The attached drawings show a revised anchor system for U2 joint armor in backwalls. The revision was made after a failure occurred on a recently constructed bridge on I40 over Cadron Creek. It appeared that the construction sequence and construction tolerances left the $\frac{3}{4}$ plate above the span when the bridge was opened to traffic. The original anchor system was insufficient when the $\frac{3}{4}$ plated acted as a cantilever. A field review of six U2 joints revealed varying degrees of contact for the $\frac{3}{4}$ plate and span. The worst joint had three points of contact with up to $\frac{3}{16}$ " gap elsewhere. In view of the observed construction tolerances and considering that the proposed LRFD specs require joint armor to be designed as a cantilever when spans are supported by elastomeric bearings, the attached changes were made. **Note the additional backwall reinforcing and new optional construction joint. We will be using this system on all jobs from today forward.

DETAIL X
No Scale

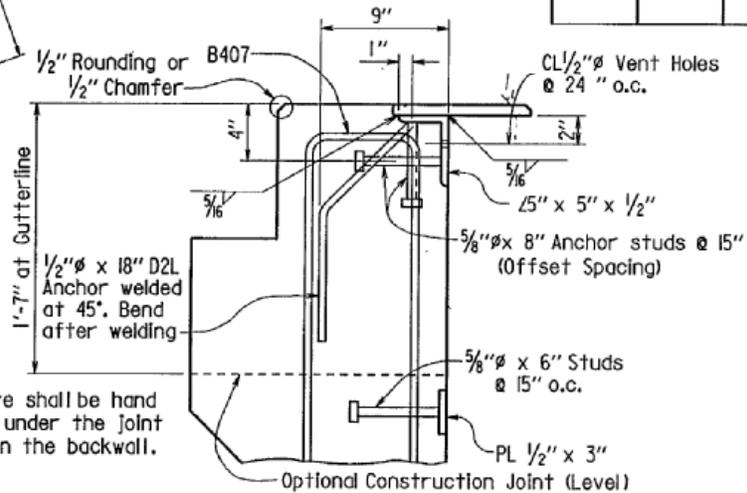
Dale said to try this on a few jobs.
